CABINET MEMBER FOR ENVIRONMENT – 21 MAY 2020

BURFORD – PROPOSED SPEED LIMIT REDUCTIONS AND SIGNALLED CROSSING ON A40 BY BURFORD SCHOOL

Report by Interim Director of Community Operations

Drawing No: Revision 0

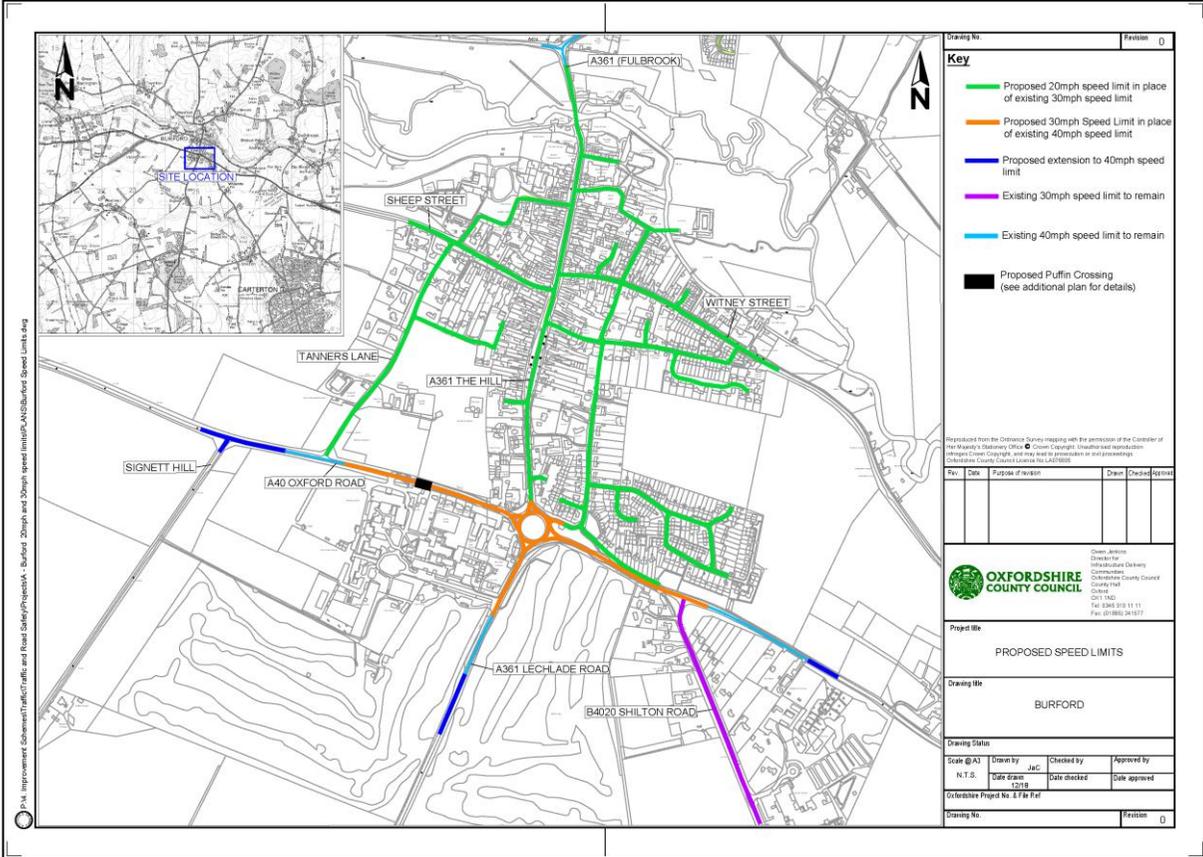
10. Thames Valley Police expressed an objection to the proposed speed limits. Specifically, they raised concerns that a 20mph speed limit on the A361 through Burford was not appropriate taking account of the 'A' road status and function as a through traffic route. They also expressed concerns over the proposed 30mph speed limits on the A40 and A361 as being unrealistic taking account of the existing speeds. They also expressed a concern that the replacement of the existing footbridge on the A40 by Burford School by a signalled crossing could be detrimental to road safety.

15. The objections to the proposed speed limits are noted. Thames Valley Police objections focussed on their appropriateness taking account of current speeds and the function of the A roads as major traffic routes. It is accepted that the proposed 30mph limits on the A40 and A361 are at the margins of compliance with the national guidance on setting local speed limits issued by the Department for Transport and the same is also the case for the 20mph speed limit on the A361 High Street, particularly in respect of the length south of the junction with Swan Lane. The objections received from other parties on the proposed speed limits were also largely on the grounds of need and appropriateness, although some responses cited the need for the 20mph speed limit to be extended further.

17. However, mindful that the length of the A361 south of the Swan Lane junction is a clearer departure from the national guidelines on setting speed limits, consideration could be given to amending the proposals for the 20mph limit to reduce its extent on the A361 The Hill.

1. The Cabinet Member for Environment is **RECOMMENDED** to approve the proposed reduced speed limits at Burford as advertised but with consideration being given to reducing the extent of the proposed 20mph speed limit on the A361 The Hill, but to defer a decision on the installation of a puffin crossing (a signalled crossing for pedestrians) on the A40 by Burford School in place of the existing footbridge.

Traffic Regulation Order
 Proposed PUFFIN Crossing

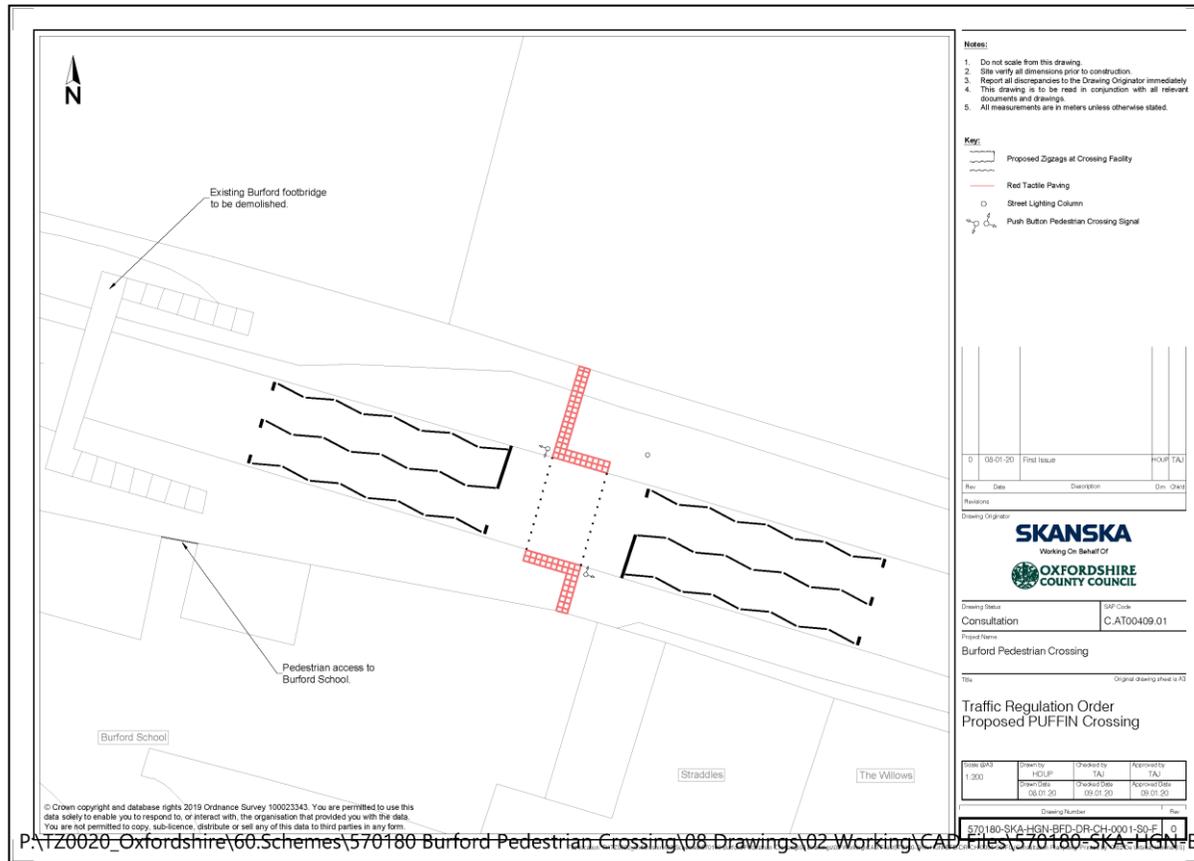
18. The strong objections to the proposed puffin crossing on road safety and traffic delay grounds, including from the staff and governors of Burford School are noted and in view of this a further review of options will be carried out and presented to a future meeting. It should be noted that while the speed limit reduction on the A40 would be highly advisable in the event of a signalled crossing being provided at a later date, local views on the need for and appropriateness of the speed limit reductions are that these are needed irrespective of whether a signalled crossing is progressed or not.
